***City of Agoura Hills Geotechnical Review Sheet for 05-
CUP-006 & 05-OTP-032 (Sunbelt Enterprises).
GeoDynamics, Inc. July 7, 2008.***

CITY OF AGOURA HILLS - GEOTECHNICAL REVIEW SHEET

Planning Case #: 05-CUP-006 & 05-OTP-032 (Sunbelt Enterprises)

Response I
Geotechnical Update Report
City of Agoura Hills Geotechnical Review Sheet dated July 7, 2008
[Planning Case No. 05-CUP-006 & 05-OTP-032 / GDI No. 05.00103.0136]
Proposed Office Buildings
29541 and 29555 Canwood Street
Agoura Hills, California

Client No.	3315	PLATE 1
Report No.	8292	
Date	9/23/08	
Drawing No.	8292cn3315	
APP. NO.		
GP. NO.

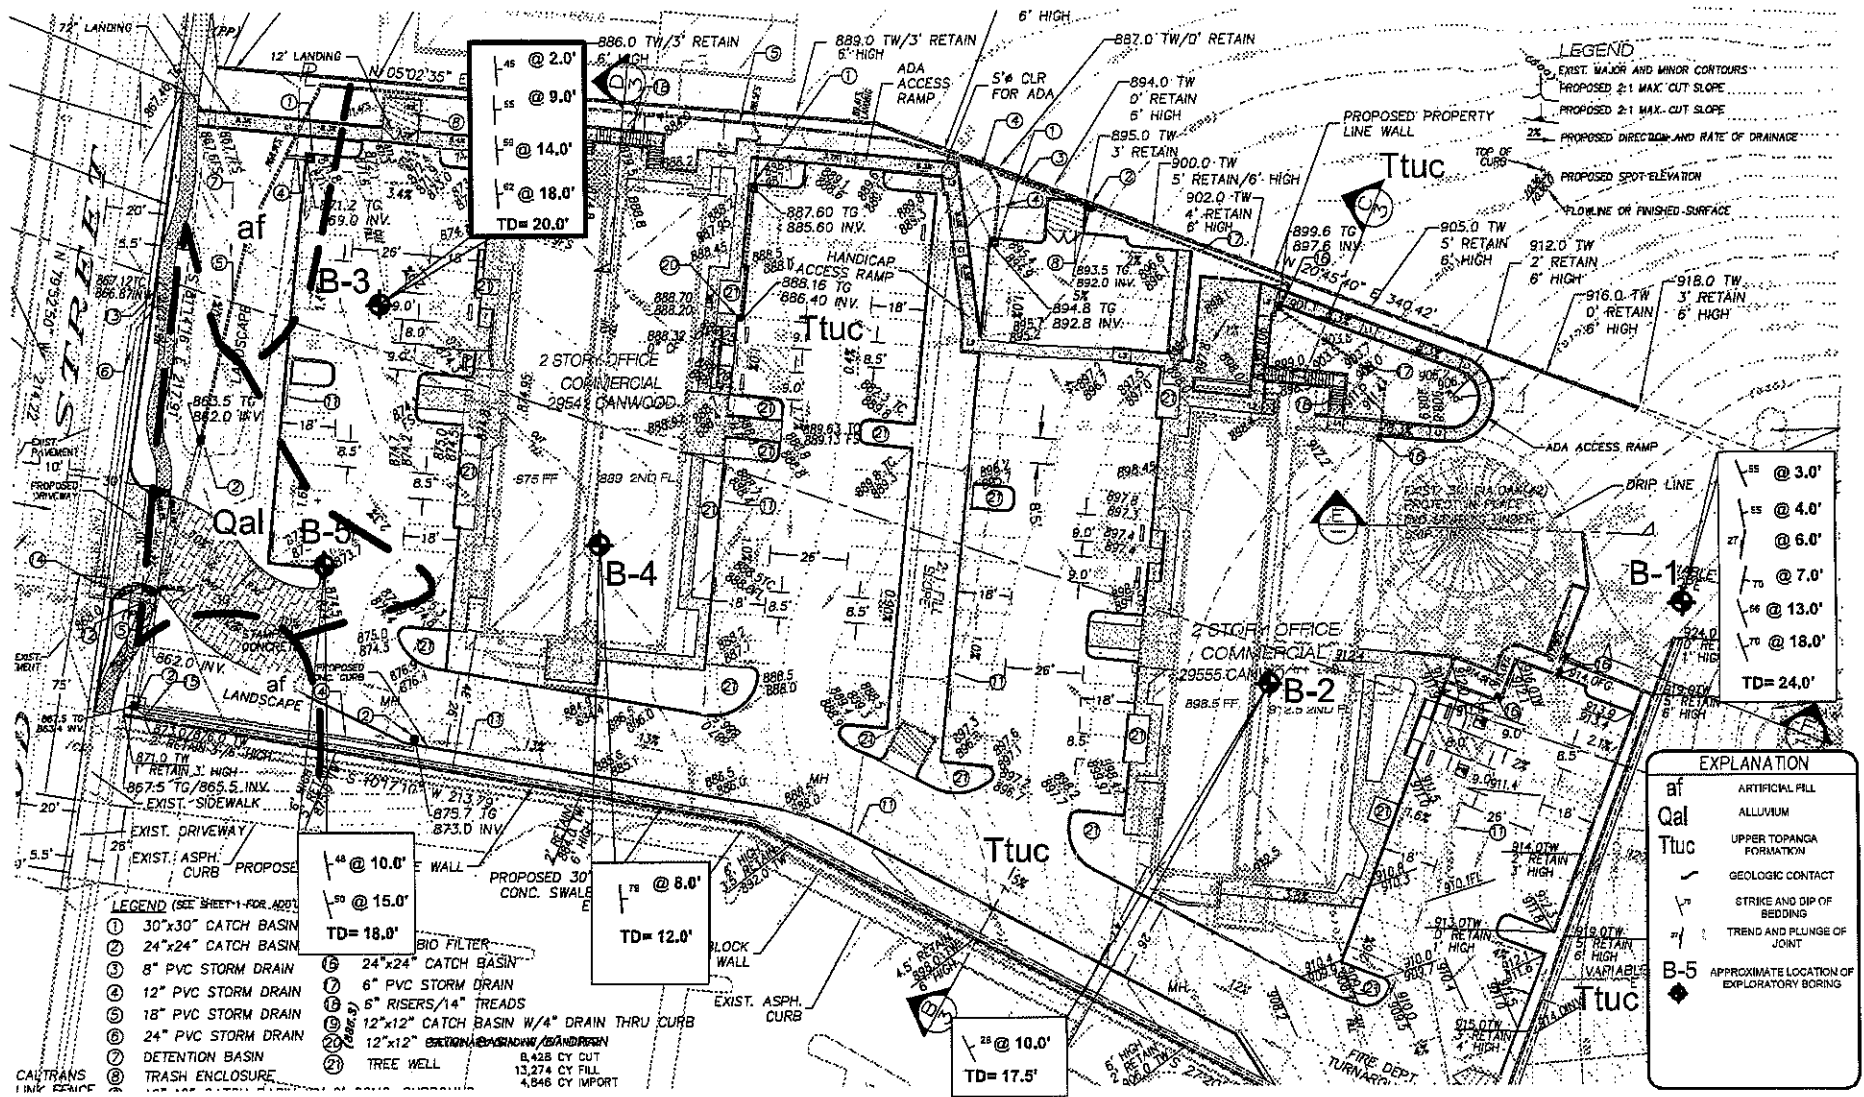
The Grading Plan included with the most recent submittal (Holmes Enterprises, 2008) differs from the plan included with the most recent AGS Update Report (April 8, 2008). The consultant should provide a geotechnical update/review of the most current plan and provide additional recommendations as necessary to address changes to the plan.

The most recent grading plan prepared by Holmes Enterprises, Inc., has been reviewed by this office. The grading plan was utilized as the base map for our *Site Plan*, which is included as Plate 1 and can be found in Appendix A, to show the locations of our borings in regards to the site grading and development. Based on our review of the most recent grading plan, the parking area located at the northwest corner of the lot has been *revised* to eliminate the need for the previously proposed 10- and 16-foot high retaining walls in the vicinity of the existing oak trees. A stepped retaining wall system with a maximum height of 5 feet and a maximum combined retained height of 10 feet is now proposed. The recommendations provided in our previous reports remain applicable to the proposed construction and grading, as now proposed.
